## EnviroArb-Solutions Ltd

### ARBORICULTURAL IMPACT ASSESSMENT

<b>Site:</b>	<b>5 Dagmar Road, London, SE25 6HZ</b>
<b>Client:</b>	<b>Mr Thomas, Inicio Homes, 16 Berkeley Street, London, W1J 8DZ</b>
<b>Date</b>	<b>19th July 2021</b>
<b>Our Ref:</b>	<b>EAS-079v3</b>

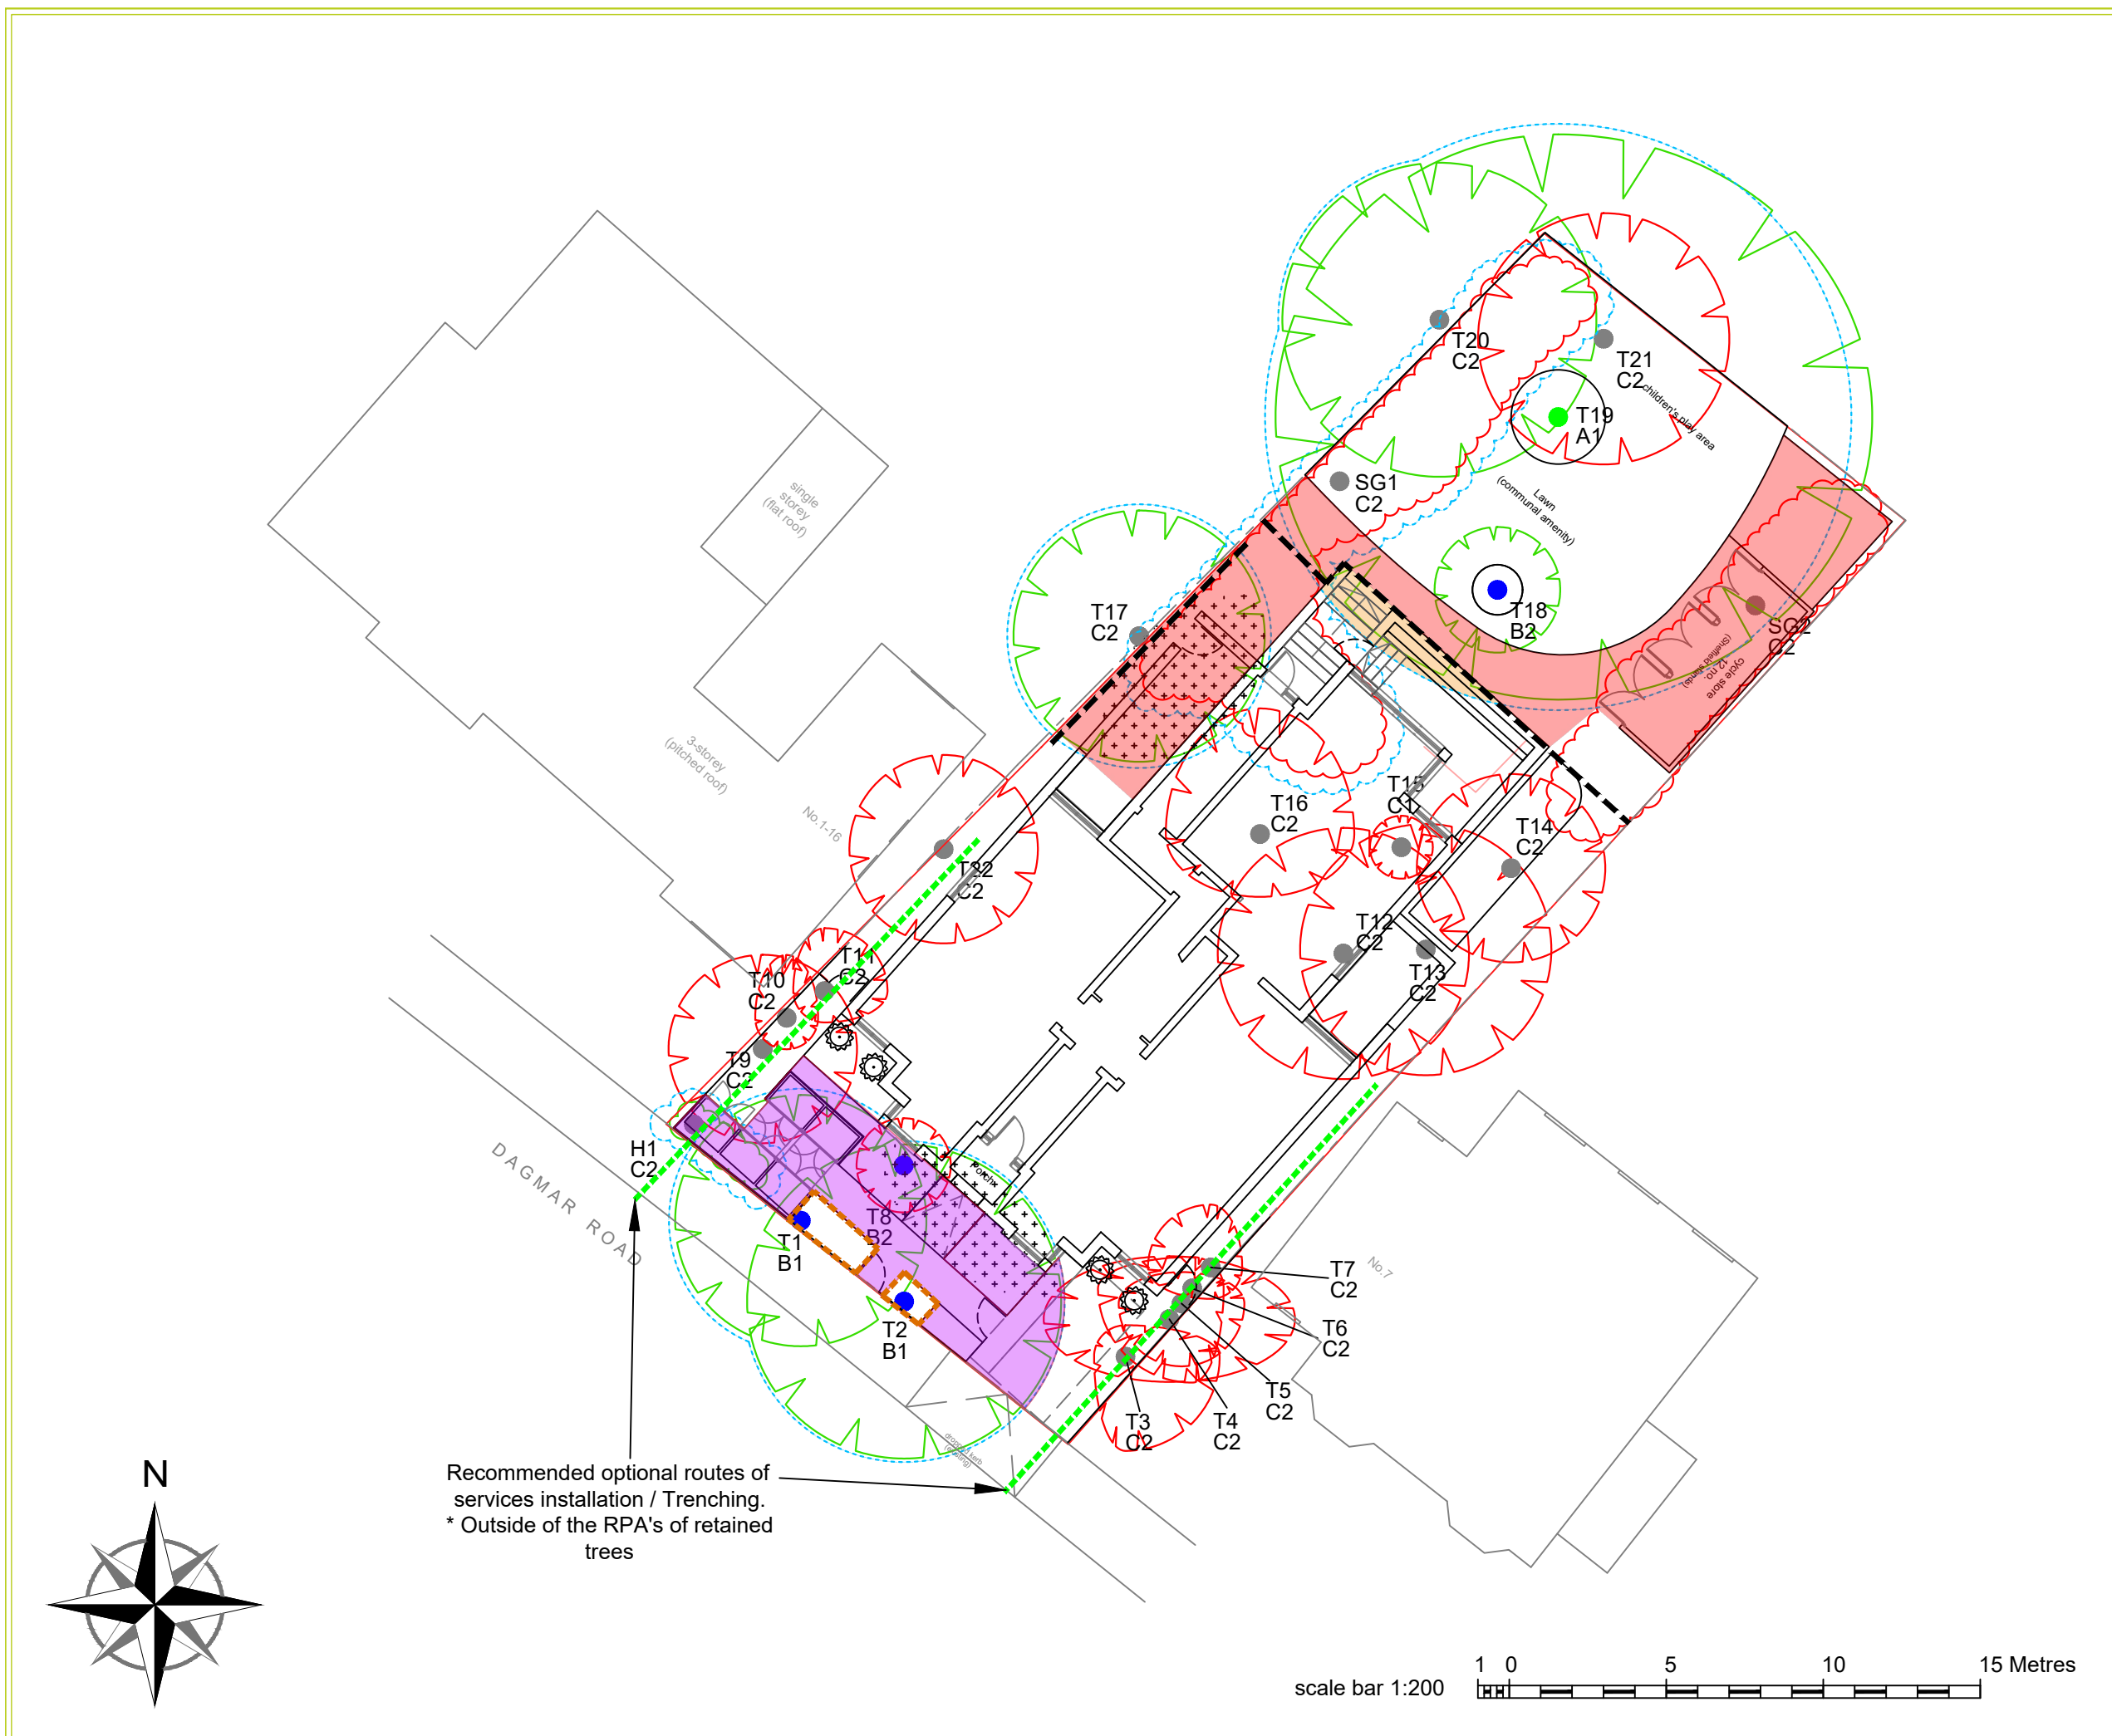
- 1.6 Following comments made by the Council tree officer and received on the 01/07/2021 the following changes were made as requested:
- 1.6.1 Insertion of additional temporary ground protection at the front within the whole of the RPA of T1 & T2 ( as indicated by the purple shading).
- 1.6.2 Amendments made to the Tree Protection Plan - specifically increased fencing for T19.

1.6.3 Confirmation from the client that they can accommodate the location of new services into the site as indicated by the Council tree officer and shown on the revised Tree Protection Plan at Appendix 4.

7.2.3 Additional temporary ground protection and enlarged Construction Exclusions zones have been included as indicated on the revised Tree Protection Plan, as requested by the Council tree officer.

7.5.2 Following recommendations from the council tree officer services routes into the site have been agreed to be located outside of the RPAs of T1 & T2, as indicated on the revised Tree Protection Plan.

No	Description	By	Date	Chkd
A	T19 move approx 1.75M NE	SPB	20-02-21	PA
B	New Baseplan, measures updated	SPB	25-02-21	PA
C	Fencing amended, TGP Enlarged	SPB	05-07-21	PA

Recommended optional routes of services installation / Trenching.  
 \* Outside of the RPA's of retained trees
